CLIENT
ZANCOR HOMES

PROJECT/LOCATION
VALLEY KING
KING CITY, ONTARIO

DRAWING
SITE GRADING PLAN

BURNSIDE
This plan has been reviewed with respect to general conformance with the overall lot grading plan only and our approval on this plan is for no other purpose.
We accept no responsibility for the accuracy of elevations and dimensions provided by others.
☐ REVIEWED WITHOUT CHANGES
☑ REVIEWED AS NOTED ~~IN RED~~
☐ REQUIRES RE-SUBMISSION
Reviewed by: Date OCT 26 2012
R. J. Burnside & Associates Limited

LOT 56 AND LOT 57 - CROSS SECTION A - A
SCALE = 1:150

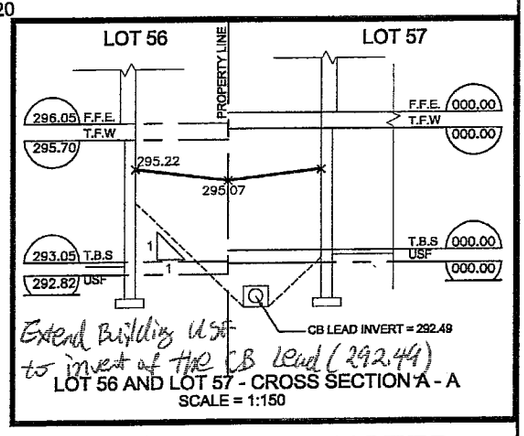
Extend Building USF to invert of the CB lead (292.49)
